Re: State Center Fire Department
Renovation & Addition – Redesign
109 E Main Street
State Center, Iowa 50247

ADDENDUM #01

January 06, 2026

EXISTING CONDITIONS &
DEMOLITION PLAN

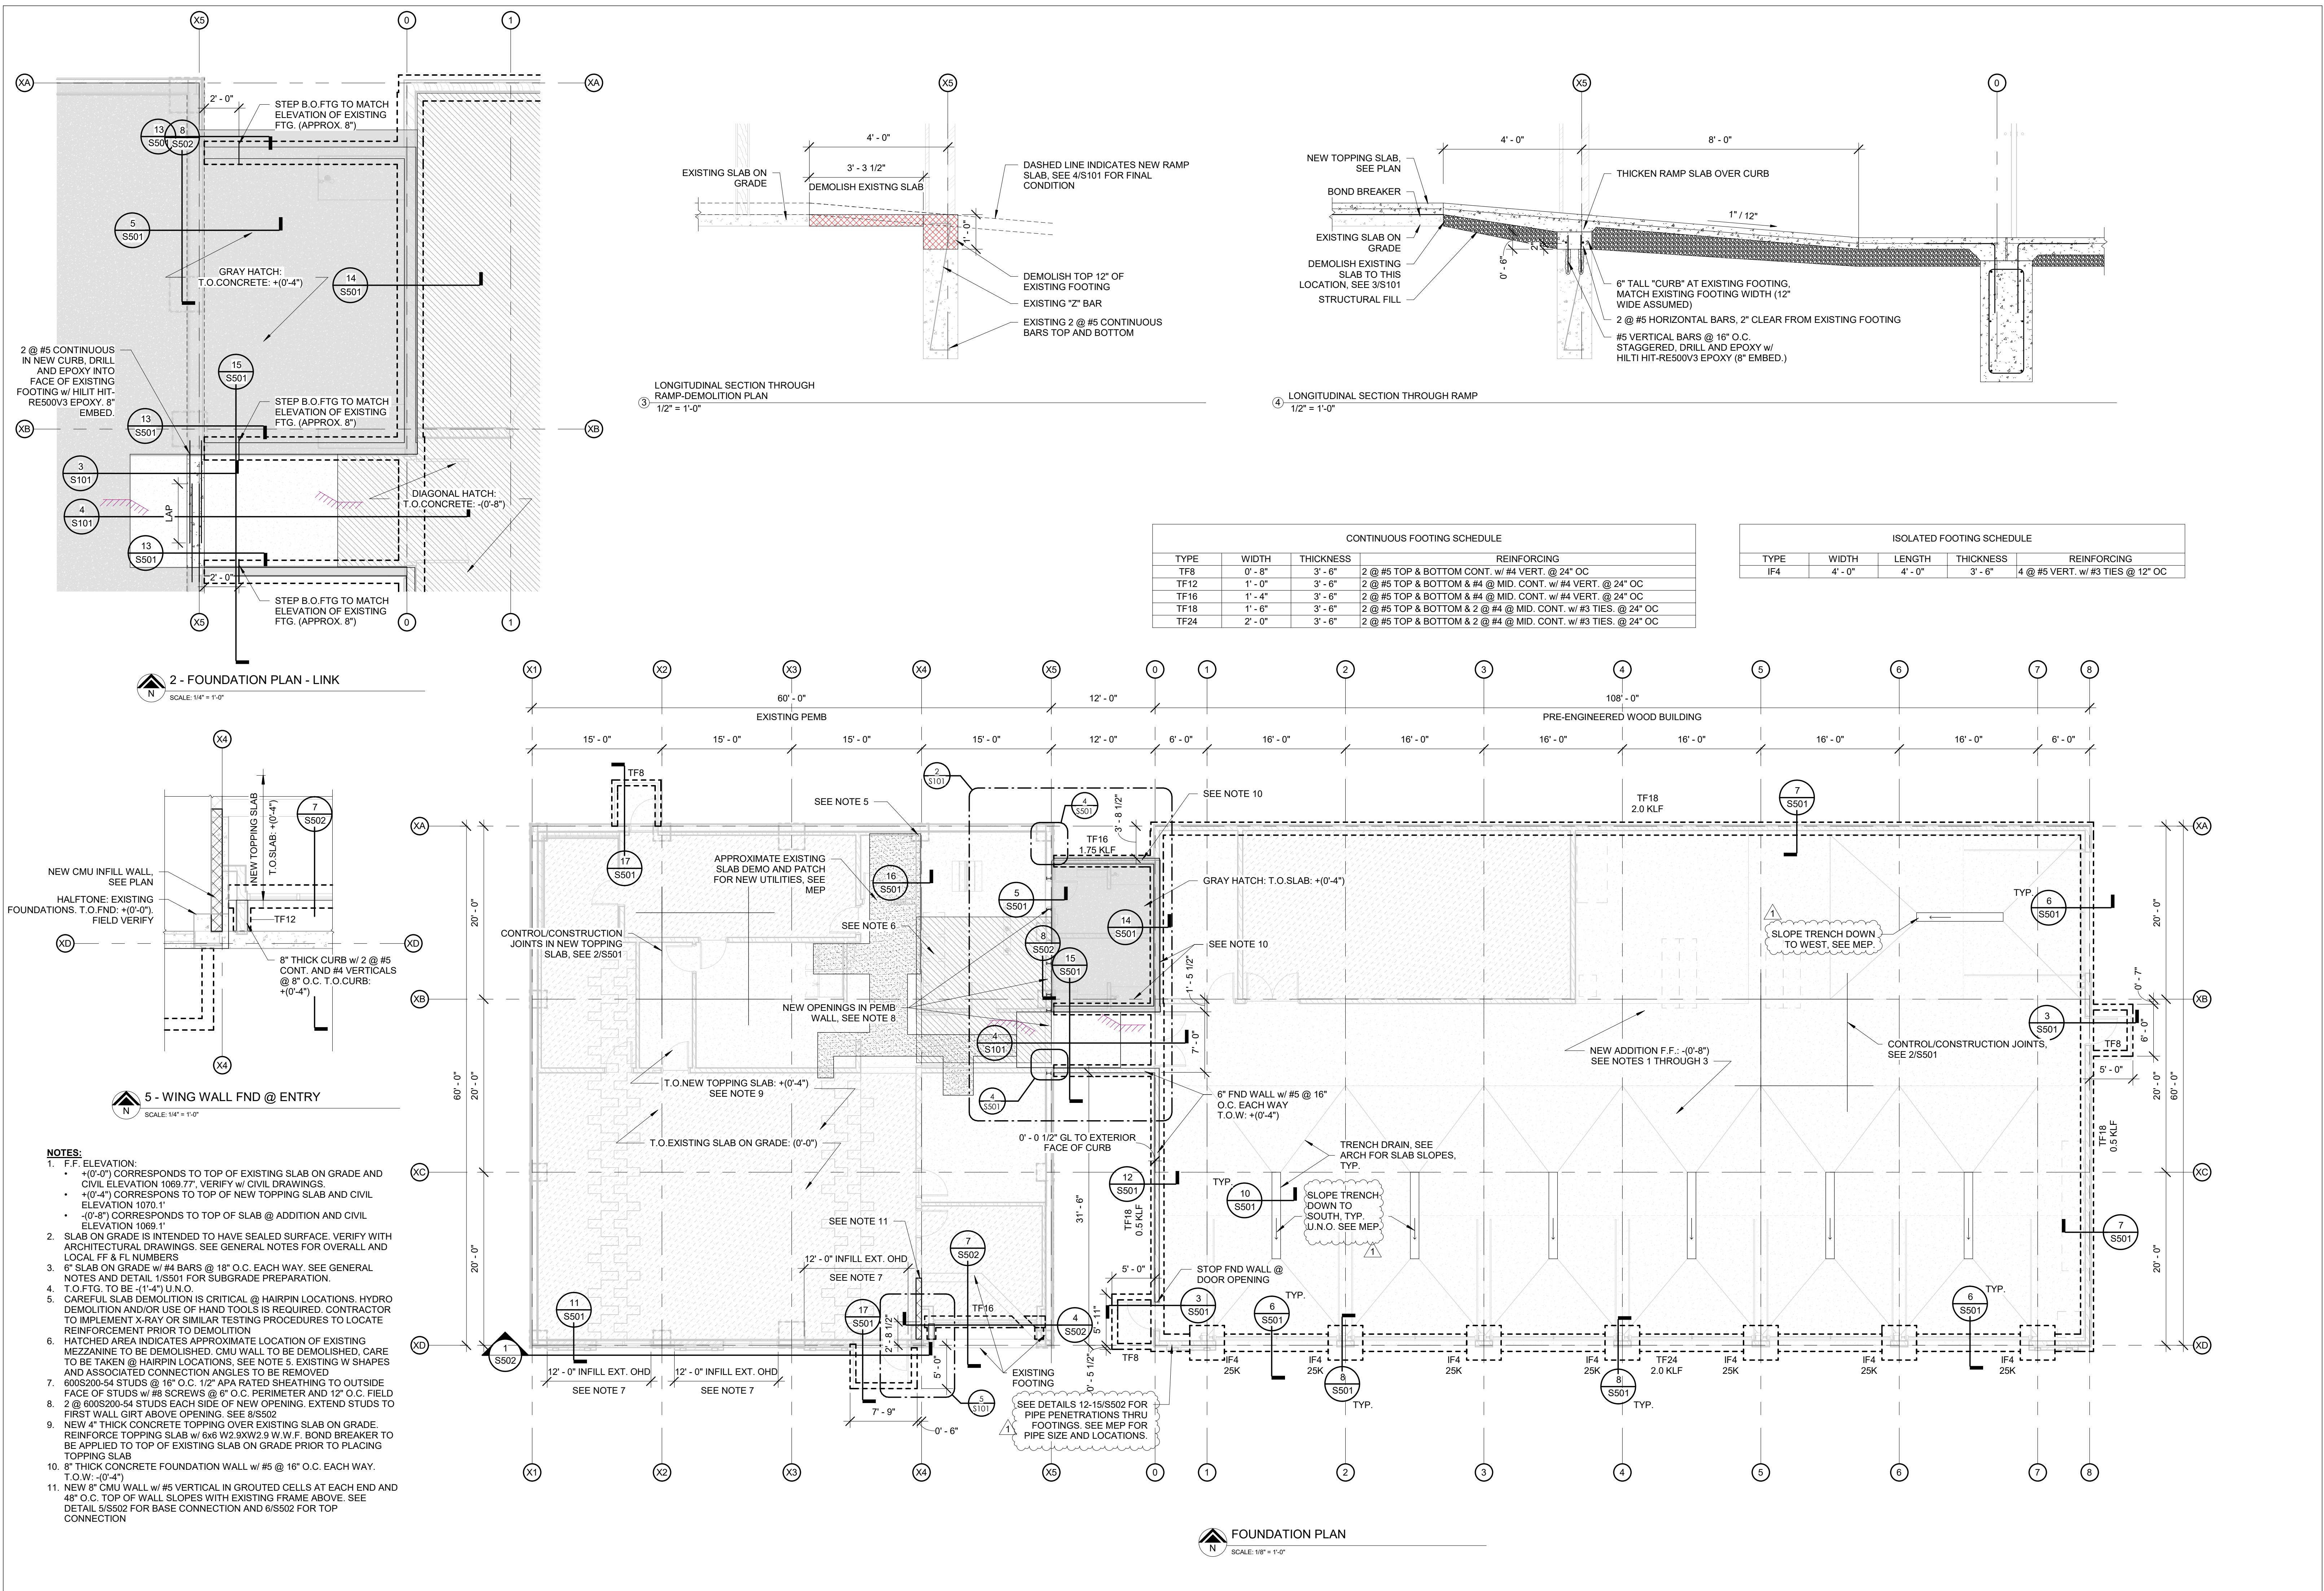
Item #C1: **SHEET C.110 – EXISTING CONDITIONS & DEMOLITION PLAN – MODIFIED SCOPE**

1. **Revise** drawing C.110 as noted below and attached:
 - a. **Remove** additional street paving & curbs for removal of sanitary & water services (existing opera house utilities).
 - b. **Remove** additional sidewalk paving for demolition of sanitary & water services (existing opera house utilities).
 - c. **Remove** water service (existing opera house utility) and cap at main. Remove and salvage existing curb stop- turn over to City.
 - d. **Remove** sanitary service (existing opera house utility) and cap at main.

N
① ROOF PLAN
1/8" = 1'-0"

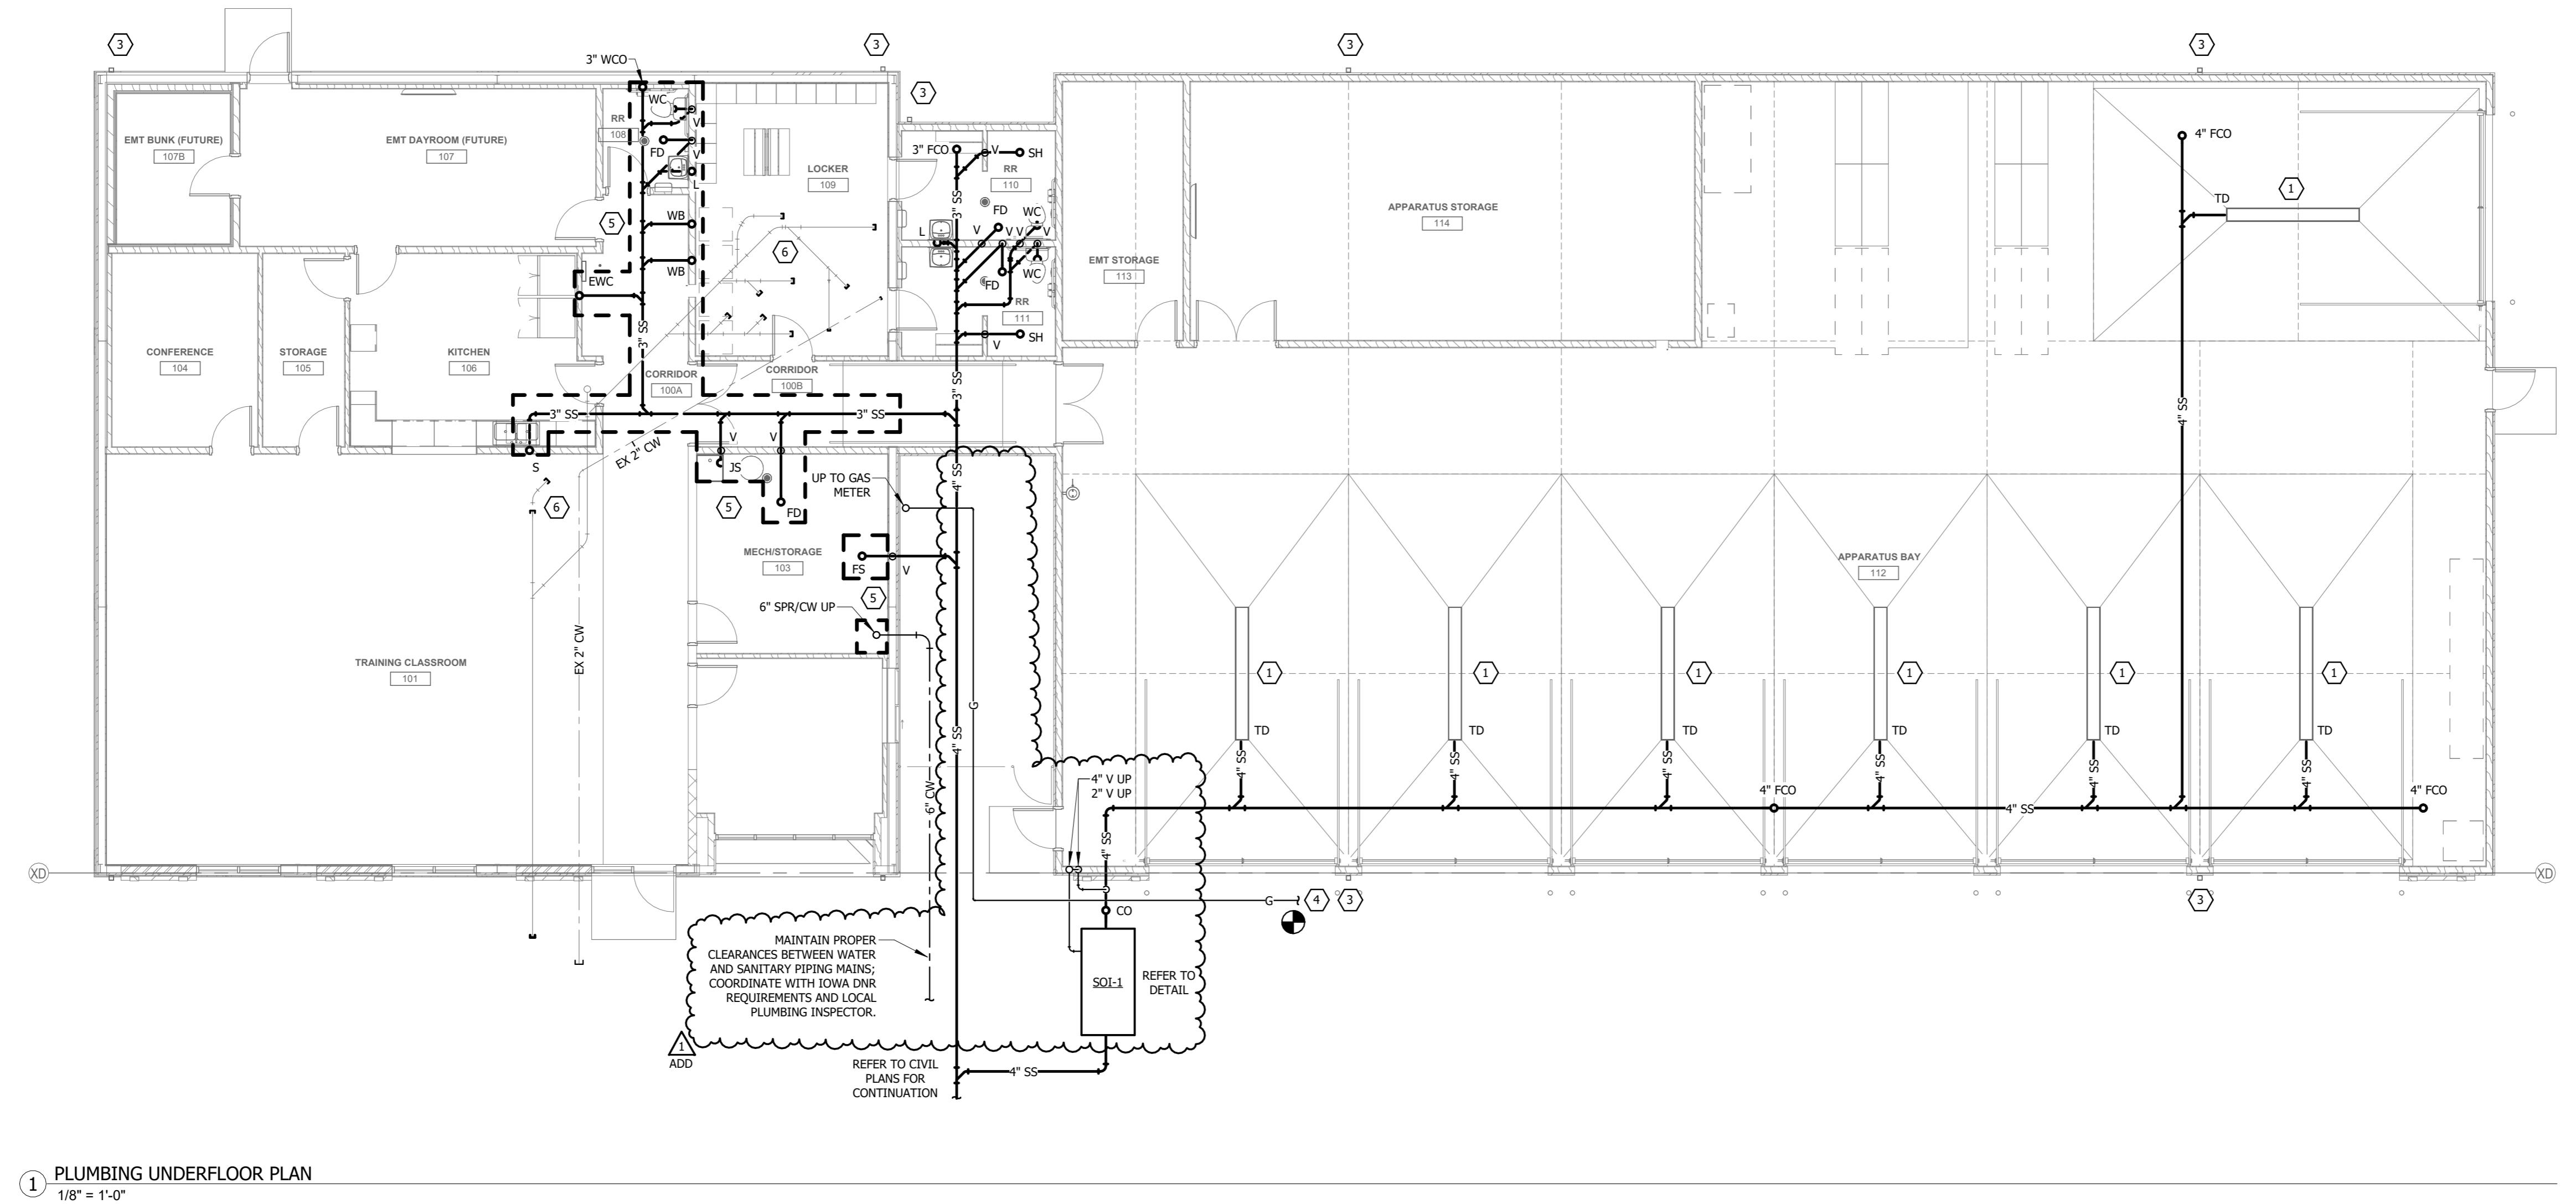
Sheet ME1.1 –Roof Plan

1. New Addition
 - A. **REVISE** 4" vents from Sand Oil Interceptor location to be at least 10 ft from combustion air duct and in line with radiant heater combustion air duct and flue.

PRINT DATE: 12.8.2025
PHASE: CD
SHEET NAME: PIPING UNDERFLOOR PLAN

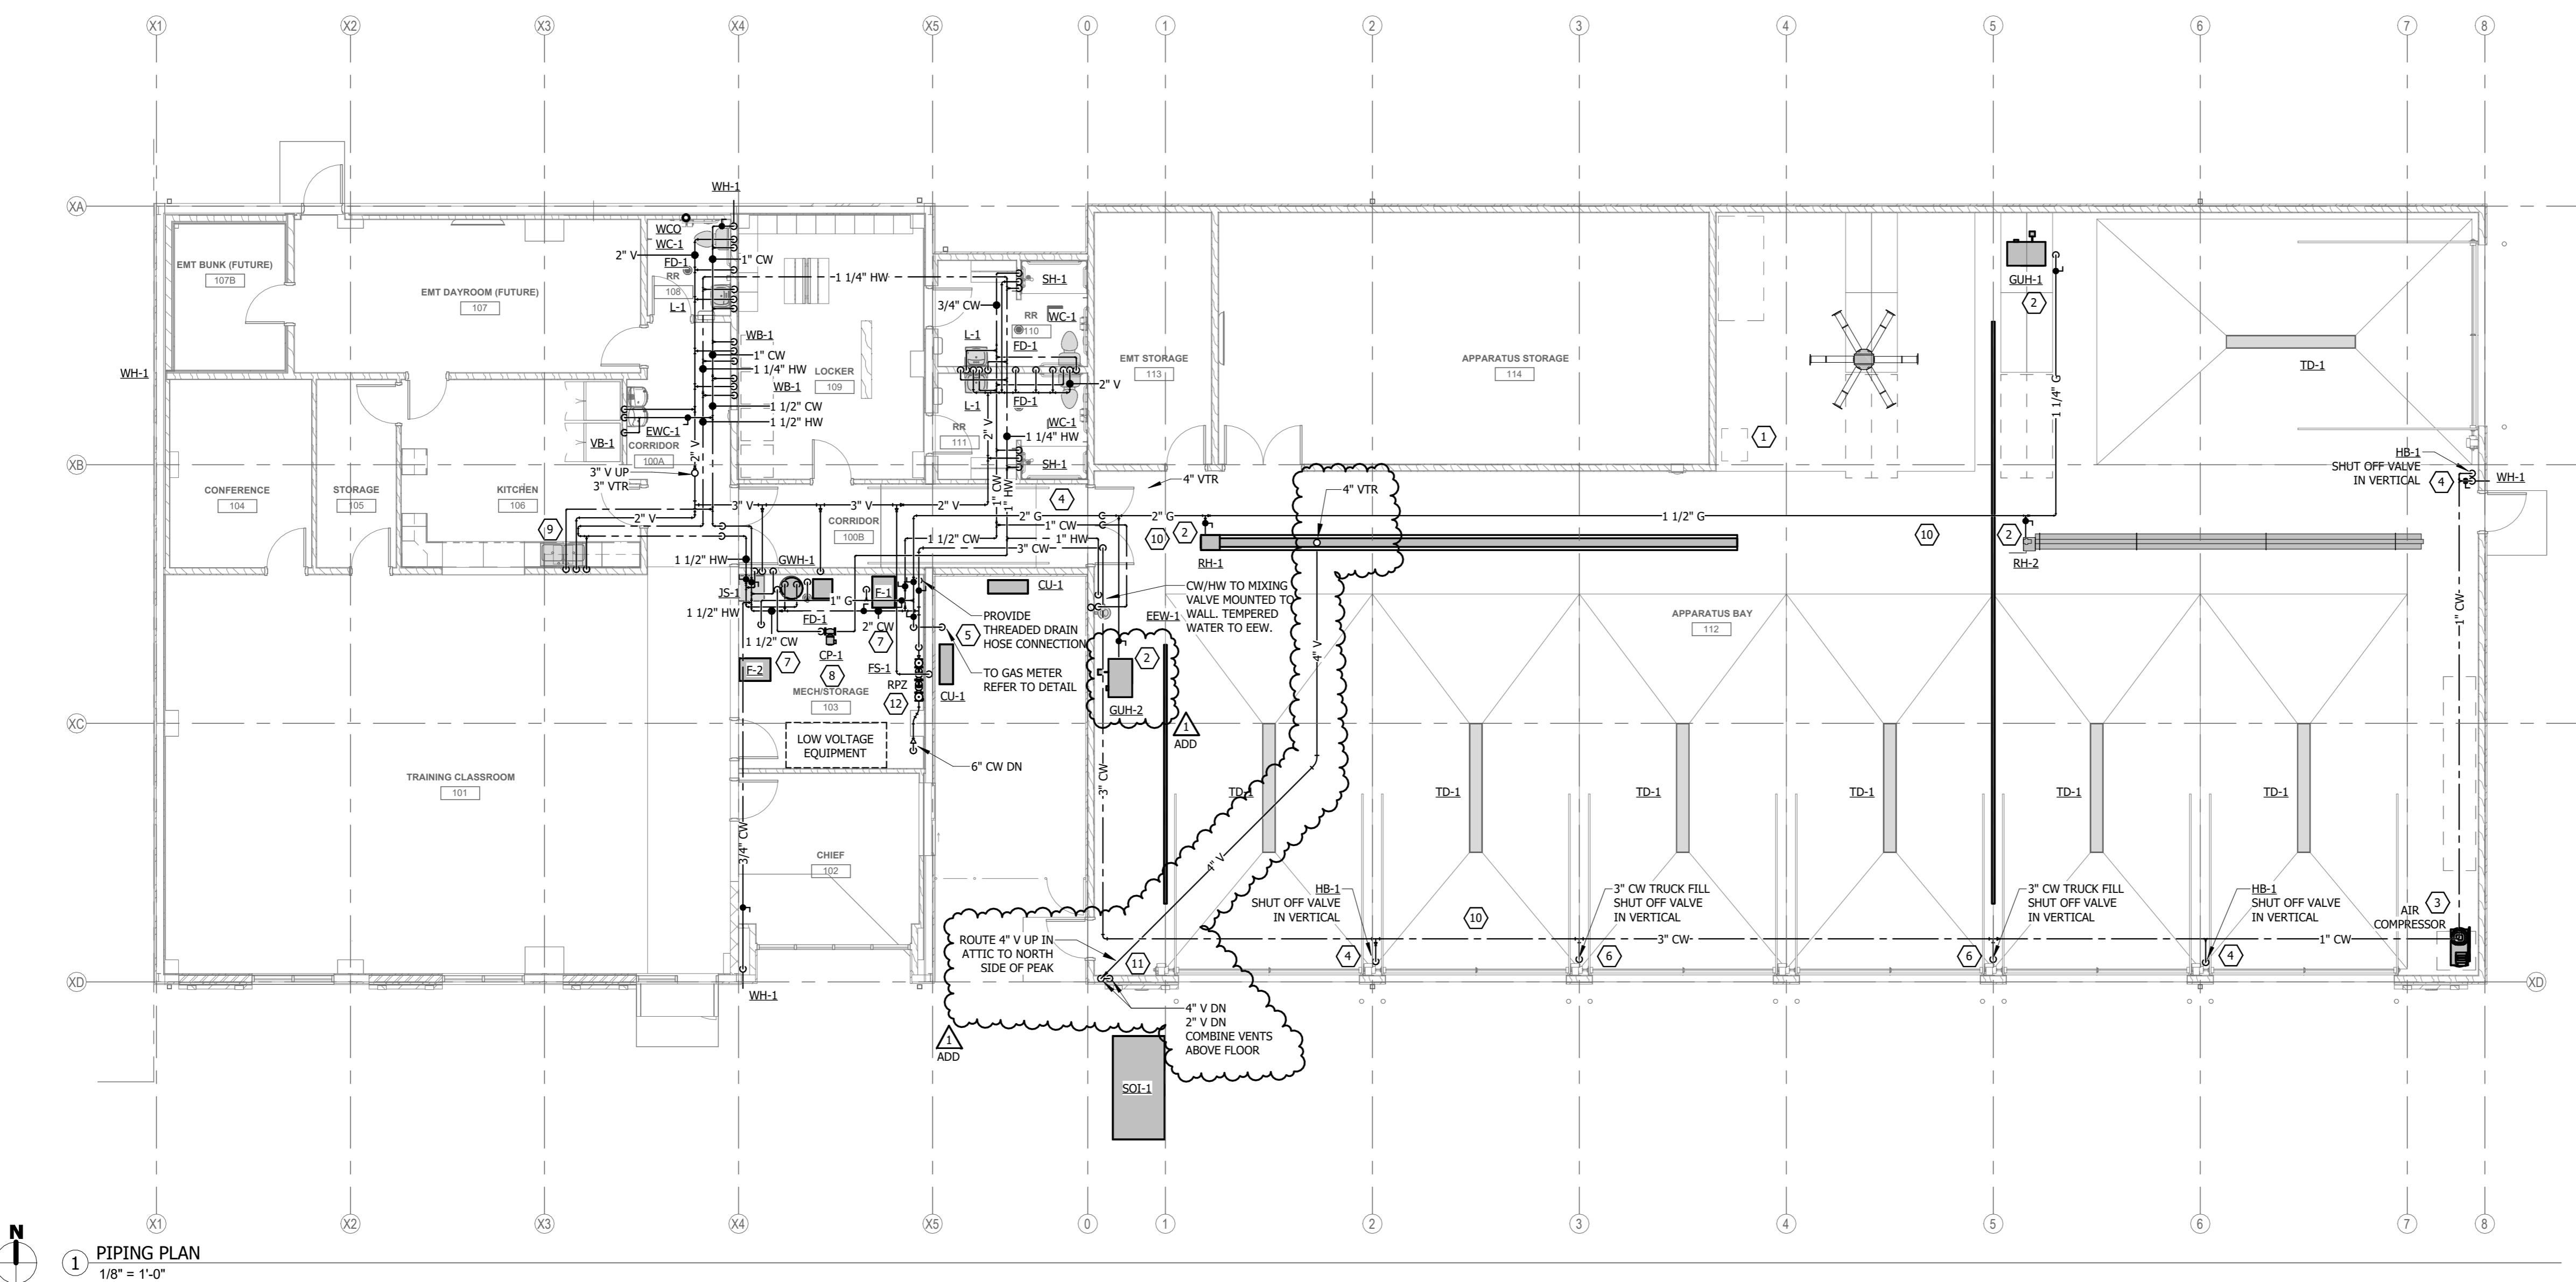
Sheet P1.0 – Piping Underfloor Plan

1. Plumbing Underfloor Plan:
 - A. **REVISE** location of gas piping layout from site main to new gas meter so not to run under door stoop.
 - B. **REVISE** Note on 6" CW site main to read, "Maintain proper clearances between water and sanitary piping mains; Coordinate with Iowa DNR requirements and local plumbing inspector."
 - C. **REVISE** 2" and 4" vents from Sand Oil Interceptor to route up in south wall of Apparatus Bay.
2. Referenced Notes:
 - A. **REVISE** Reference Note 1 to read, "Provide new trench drain. Refer to architectural documents for more information on proposed sloped floor slab extents and proposed trench drain rim elevations."
